Access Compliance Report

Public Rights-of-Way (Curb Ramps)

Intersection ID: 2832	Main Street: GOLDENFIELD_DR	Cross Street: DEARVIEW_LN	Location: S
ADA ID: 3EBB5C2972F4	Ramp Type: PerpDiag	Initial Pass/Fail: Fail	Overall Compliance: No
		Severity Score: 12.5

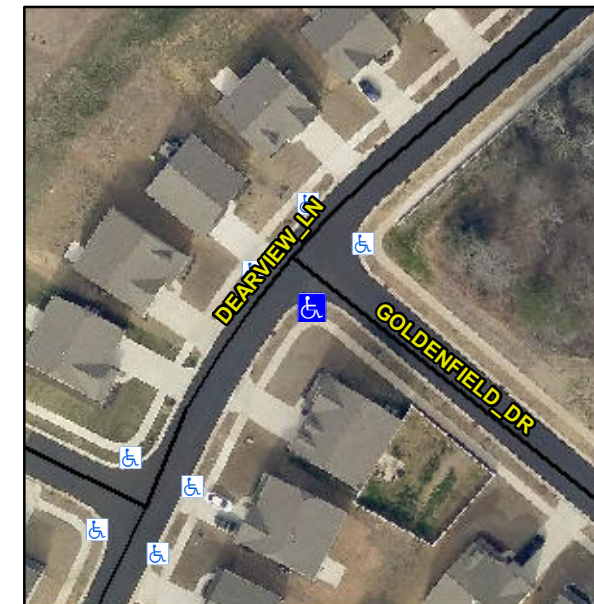
Not Found, R304.2.2

Compliance	Description	Data	Compliance	Description	Data
N/A	Ramp Length (in)	72.0	No	Ramp Slope (%)	8.4
Yes	Ramp Width (in)	48.0	Yes	Ramp XSlope (%)	0.4
N/A	Flare Type LT	N/A	N/A	Flare Type RT	N/A
N/A	Flare Slope LT (%)	N/A	N/A	Flare Slope RT (%)	N/A
N/A	Flare Traversable LT?	N/A	N/A	Flare Traversable RT?	N/A
N/A	Landing Length (in)	N/A	N/A	DWS Provided?	N/A
N/A	Landing Width (in)	N/A	N/A	DWS Contrast?	N/A
N/A	Landing Slope (%)	N/A	N/A	DWS Length (in)	N/A
N/A	Landing X Slope (%)	N/A	N/A	DWS Full Width?	N/A
N/A	Landing Curb? (Y/N)	N/A	N/A	DWS Offset (in)	N/A
N/A	Shared Landing?	N/A			
N/A	Gutter Ponding?	N/A	N/A	Gutter Slope (%)	N/A
N/A	Gutter Lip Ht (in)	N/A	N/A	Gutter X Slope (%)	N/A
N/A	Painted X Walk1?	No	N/A	Painted X Walk2?	No
	X Walk 1 Direction	To NE		X Walk 2 Direction	To NW
N/A	X Walk 1 Width (in)	N/A	N/A	X Walk 2 Width (in)	N/A
	X Walk 1 Slope (%)	0.7		X Walk 2 Slope (%)	0.7
	X Walk 1 X Slope (%)	2.2		X Walk 2 X Slope (%)	1.7

Remove & Replace Curb Ramp With Two New Directional Ramps or Equivalent.
